# ADDENDUM

Date Issued:	July 28, 2025
Project:	Intermountain Health Alta View Hospital – IR Rad Room #2 Remodel 9660 South 1300 East Sandy, Utah 84094
Addendum Number:	1

## IR Rad Room #2 Remodel

NJRA Project # 24239.00  
Construction Documents June 4, 2025  
I Addendum I July 28, 2025

A122

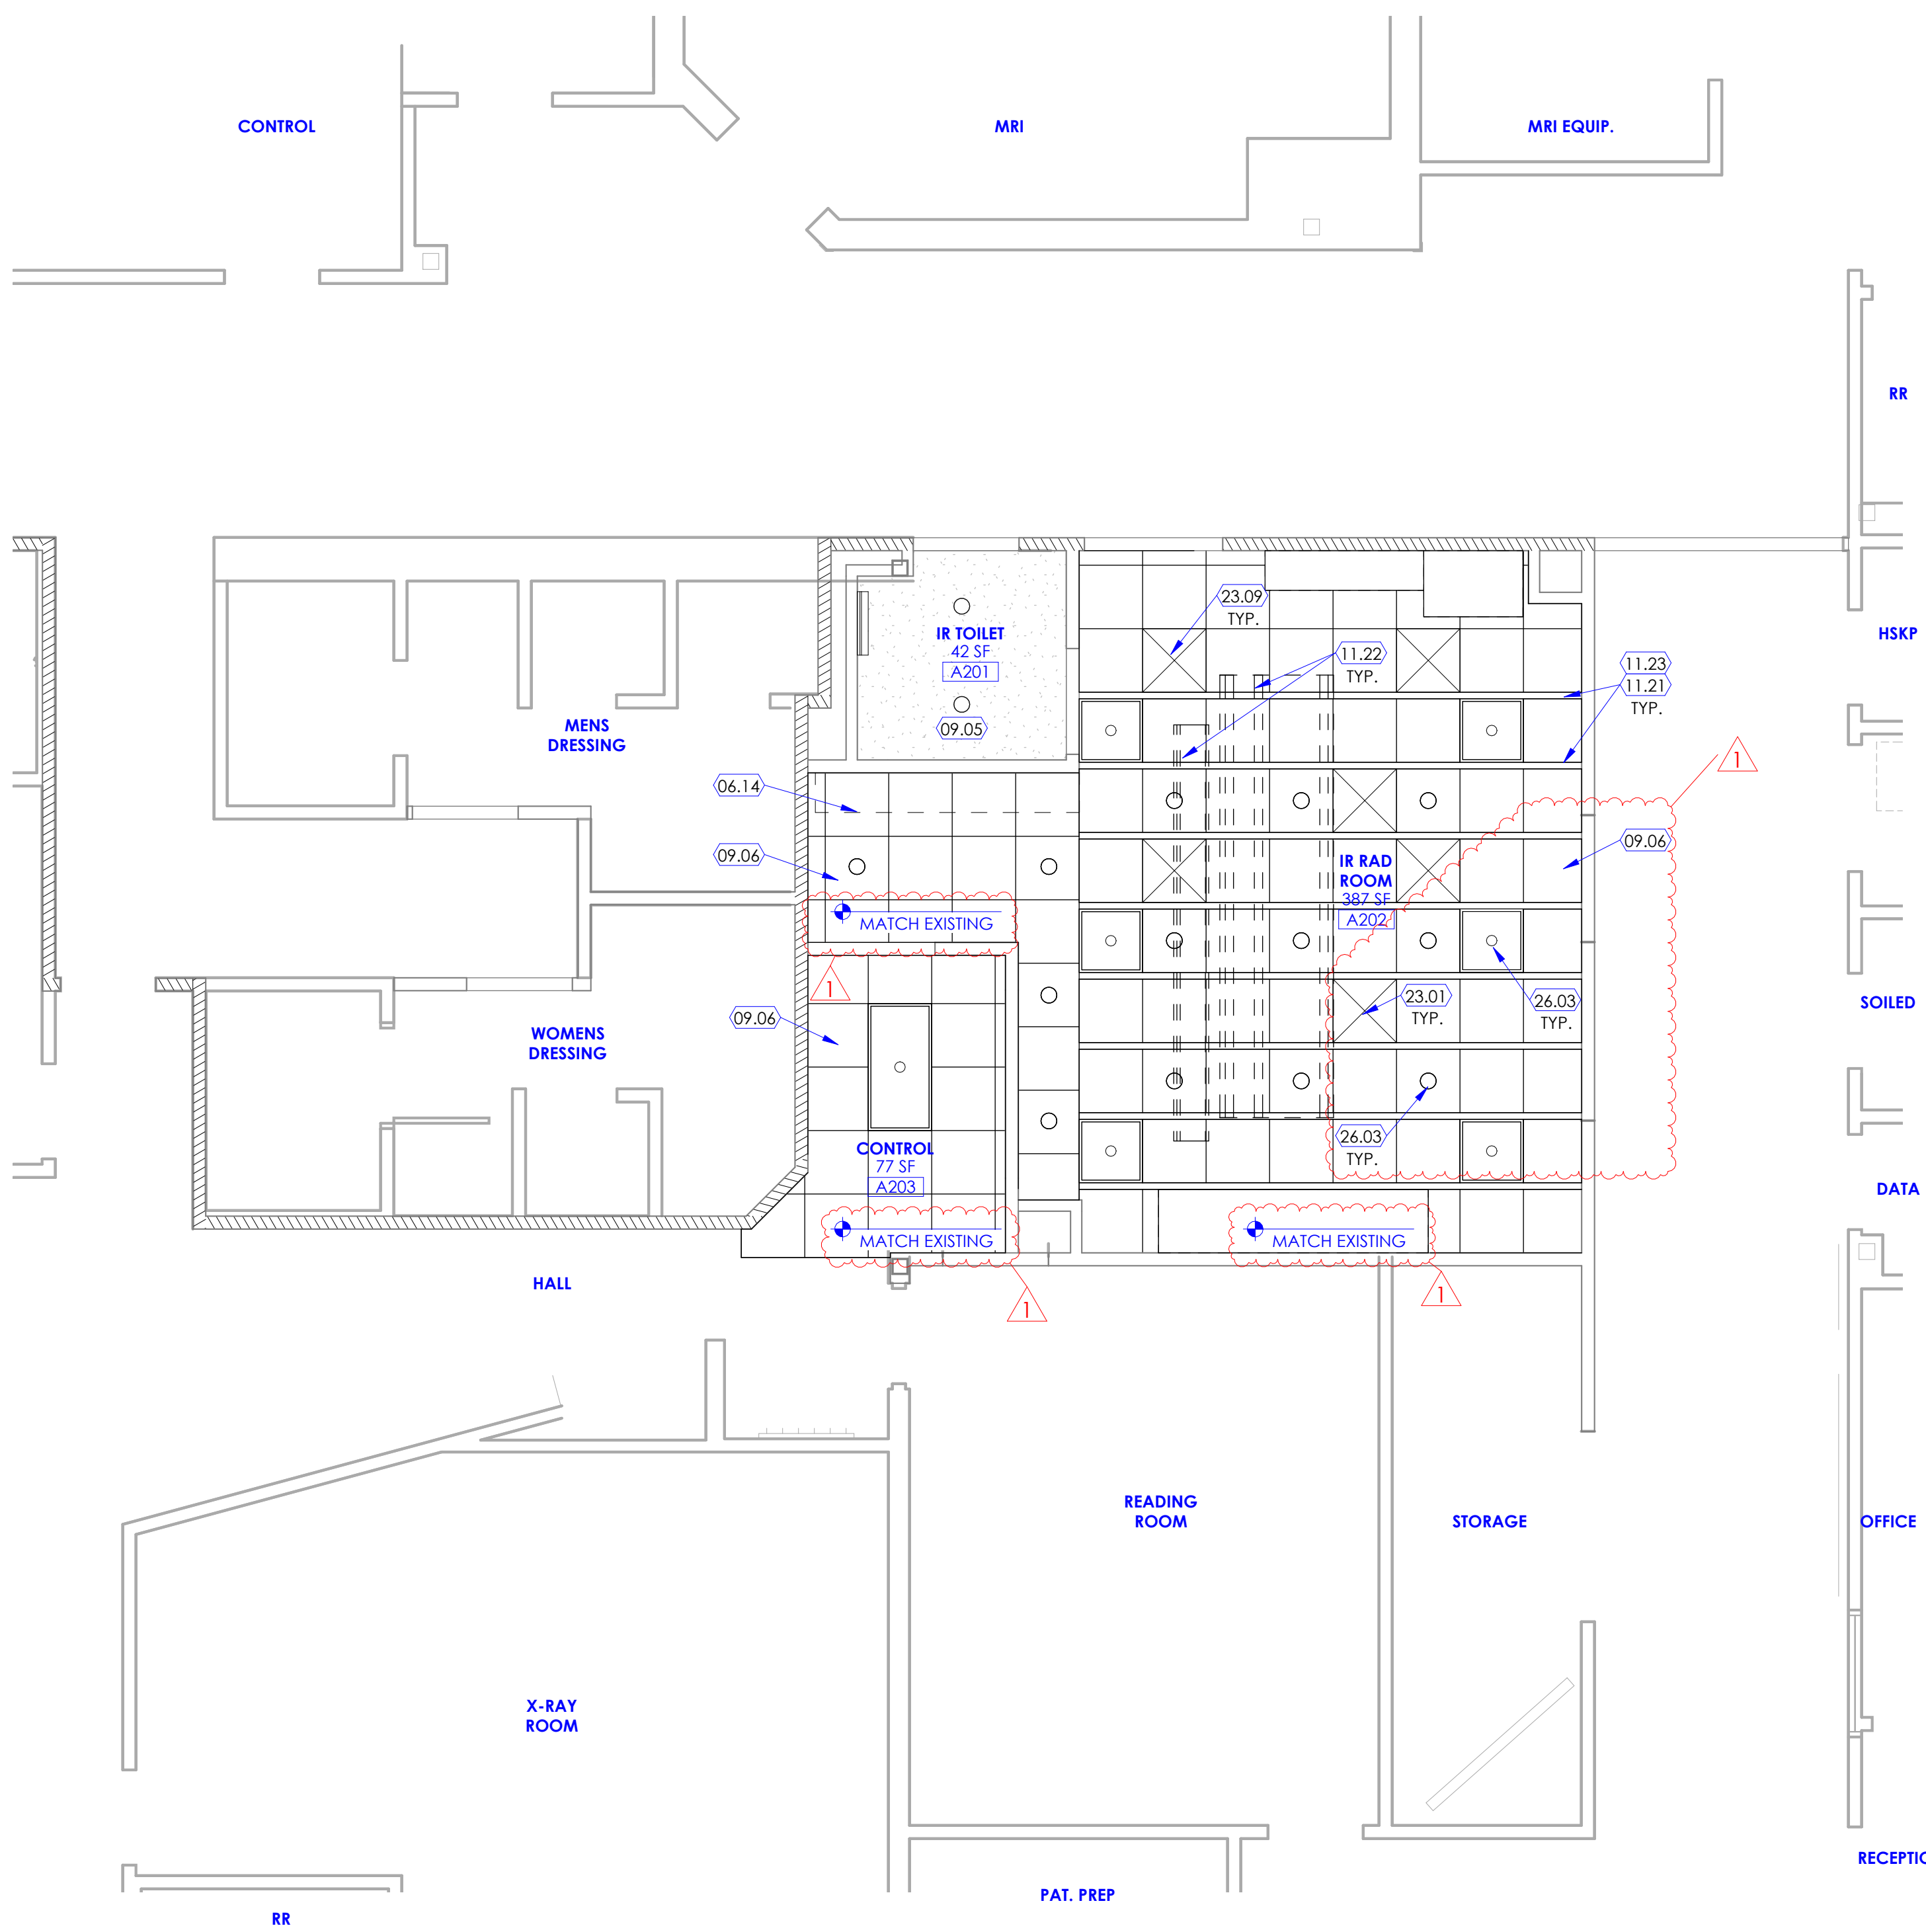
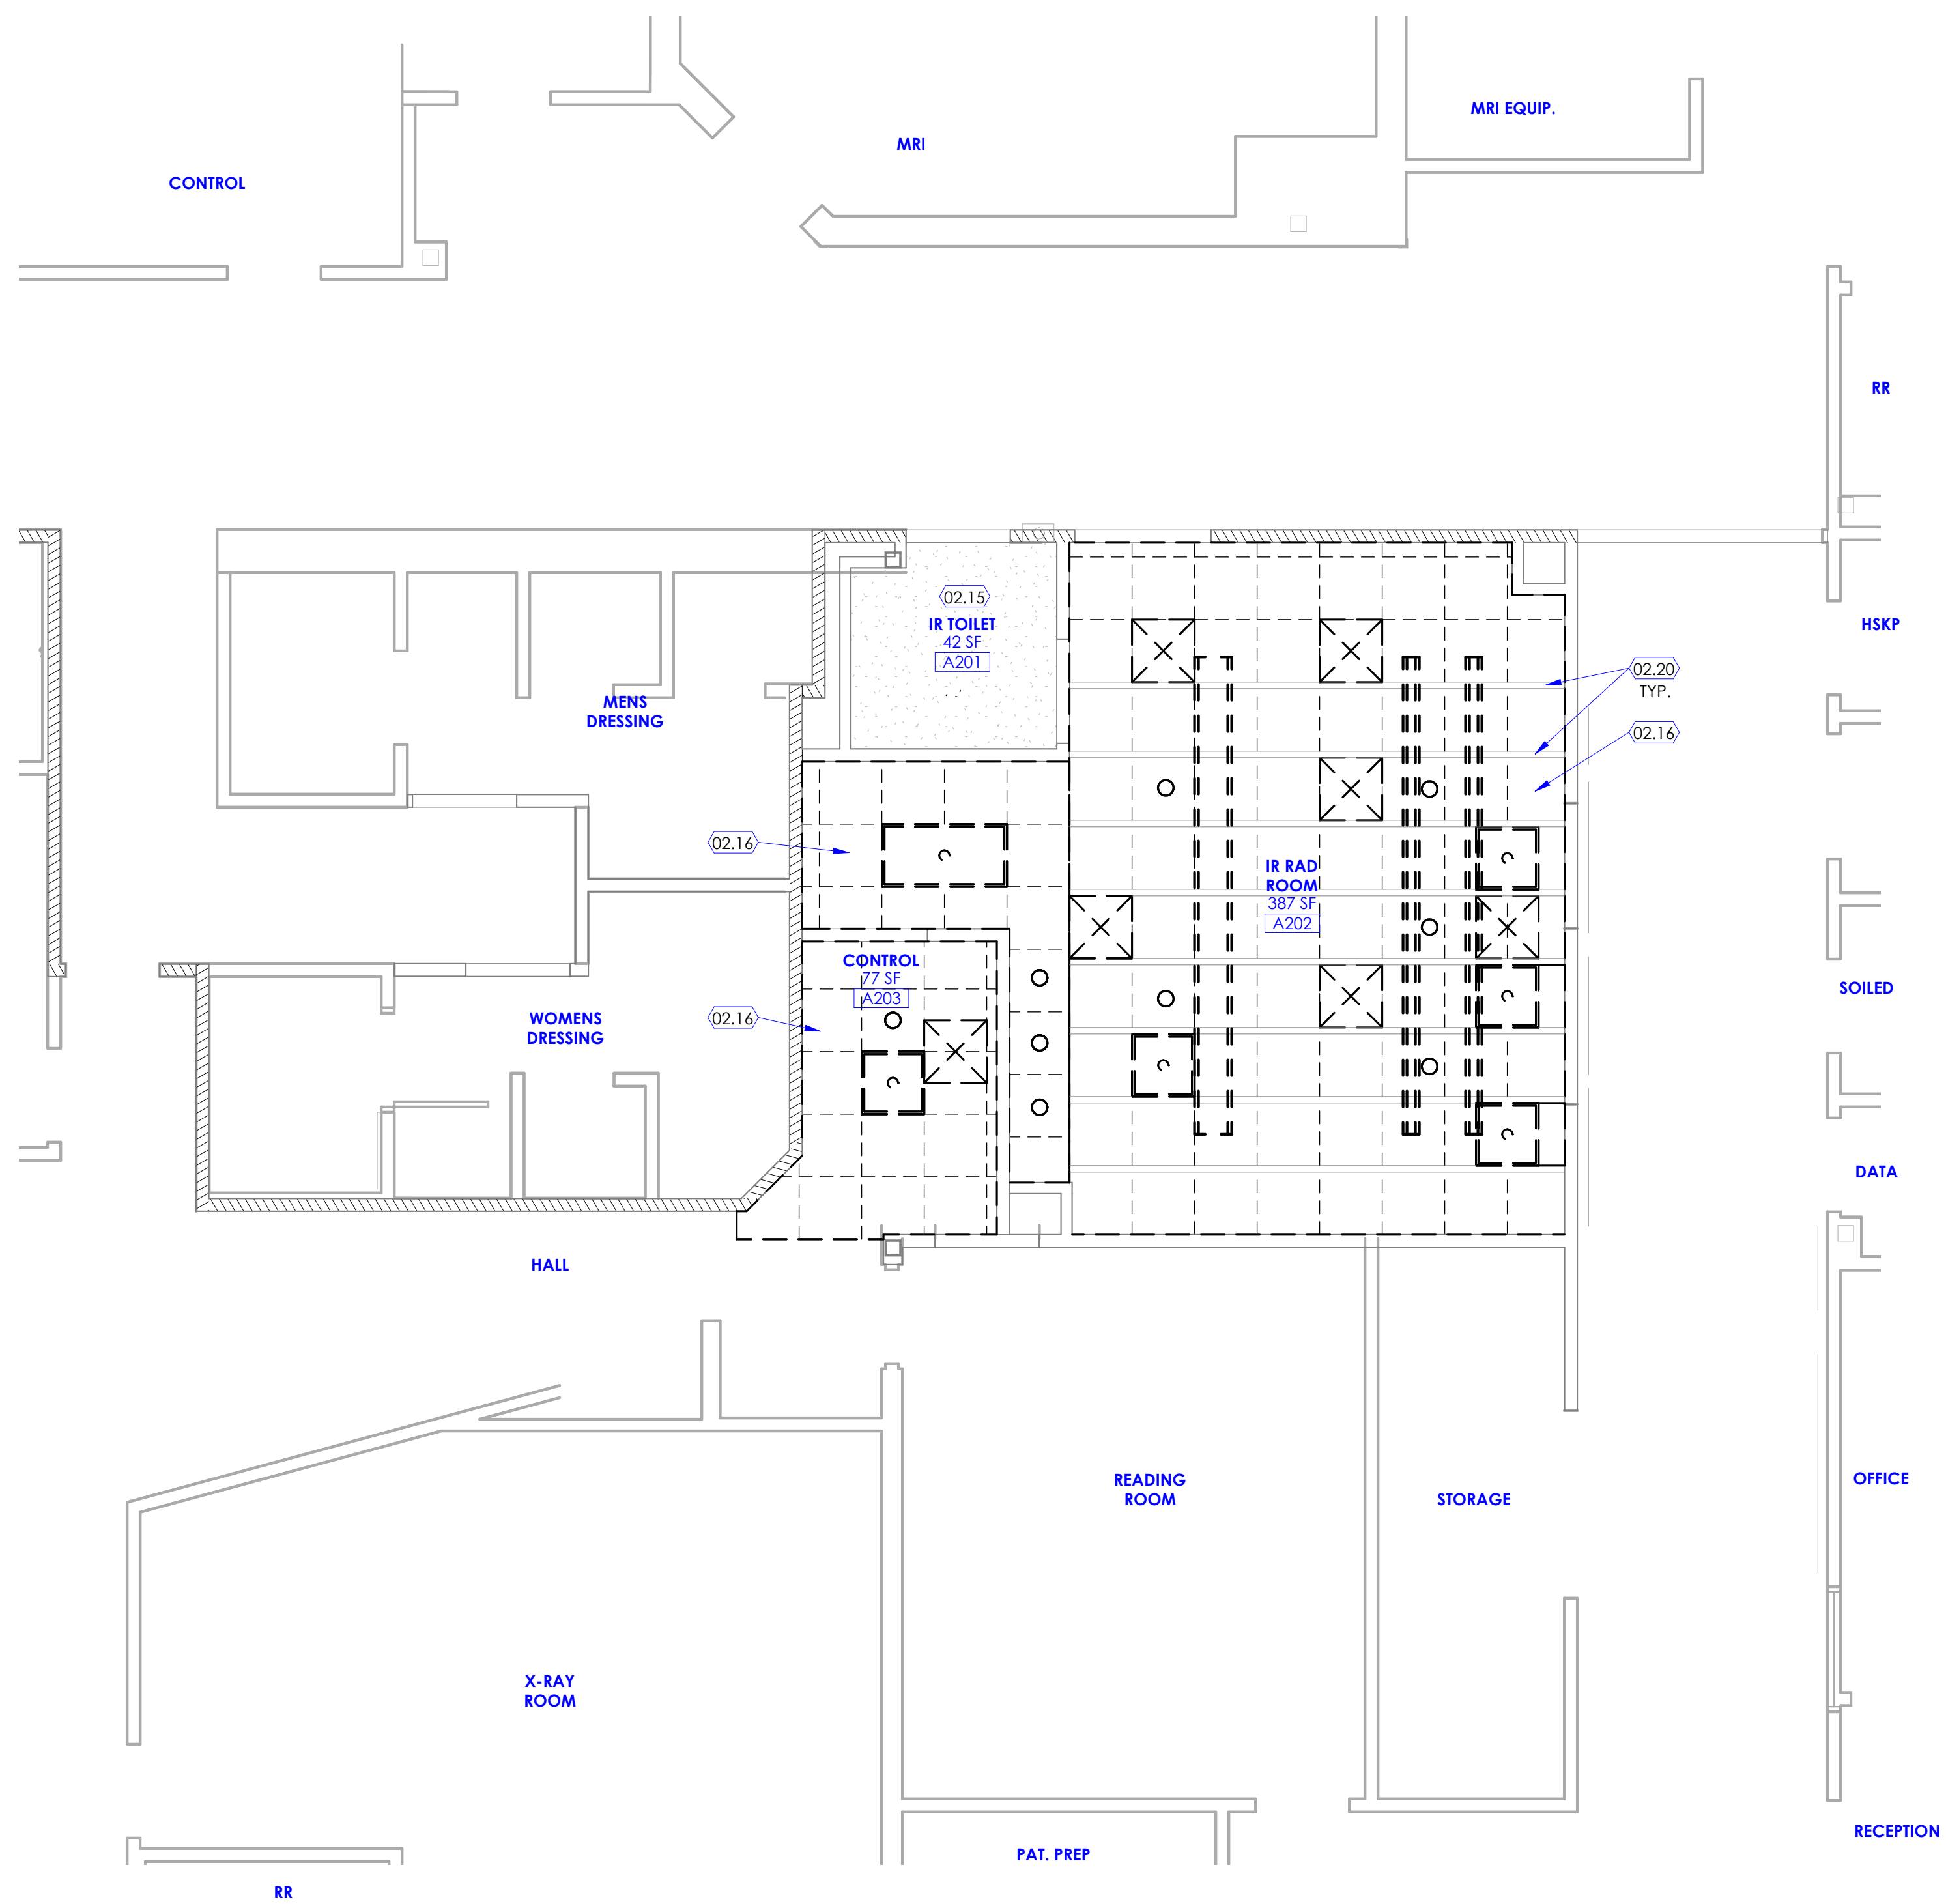
Sheet Number	Drawings
	Revise fascia above existing cabinets in one location to be vertical instead of sloped top.
A122	Revise keynote 02.16 to clarify existing grids to remain. Add keynote 06. for vertical fascia above cabinets. Revise keynote 09.06 to give a basis of design for new ceiling tiles. Add keynote 23.01 to clarify mechanical diffusers to be coordinated in ceiling. Add keynote 26.03 to clarify electrical lighting in ceiling. Indicate ceiling heights are to match existing.
A251	Detail 1/A251, Revise fascia in to be a vertical fascia to ceiling and change keynote to 06.13. Add keynote 06.01, 10.03, and 10.04 to maintain health department requirements for locking cabinet beneath sink, paper towel dispenser and soap dispenser in sink proximity. Detail 2/A251, Revise countertop height to reflect existing conditions that do not allow for a backsplash and revise keynote 11.19 for monitor wall bracket coordination with facility. Detail 4/A251 Revise countertop height to reflect existing conditions that do not allow for a backsplash and add keynote 08.02 to identify lead shielded door to be protected. Detail 5/A251 Add keynote 08.02 to identify lead shielded door to be protected.

- 02.16 REMOVE EXISTING ACOUSTIC CEILING TILES, AND CEILING MOUNTED FIXTURES AND GRILLES. SALVAGE CEILING MOUNTED ITEMS AND RETURN TO OWNER. EXISTING CEILING GRID TO REMAIN AND BE RE-USED, UNLESS REQUIRED TO BE REMOVED TO COMPLETE ABOVE CEILING WORK DESCRIBED IN THE CONSTRUCTION DOCUMENTS. REPLACE WITH MATCHING CEILING GRID WHEN REMOVED.

- 09.05 PATCH AND REPAIR GYPSUM SURFACES AS REQUIRED FOR NEW LIGHTING.
- 09.06 NEW ACOUSTICAL CEILING TILES, TO BE ARMSTRONG ULTIMA HEALTH ZONE (ITEM # 1935) 24" X 24" X 3/4" EDGE DETAIL: SQUARE LAY-IN. VERIFY CEILING TILE TYPE TO MATCH EXISTING FACILITY. UTILIZE EXISTING CEILING GRIDS WHERE POSSIBLE. WHERE CEILING GRIDS ARE DAMAGED DUE TO NEW CONSTRUCTION, REPLACE CEILING GRIDS. GRIDS SHALL MATCH EXISTING AND SHALL BE 15/16" PRELUDE XL EXPOSED TEE HEAVY DUTY. ANGLE MOLDING SHALL BE 7/8" WITH BERC 2 CLIPS. SEE DETAILS ON SHEET A503A. COORDINATE LOCATION OF CEILING MOUNTED ITEMS WITH M/E/P AND EQUIPMENT DRAWINGS.
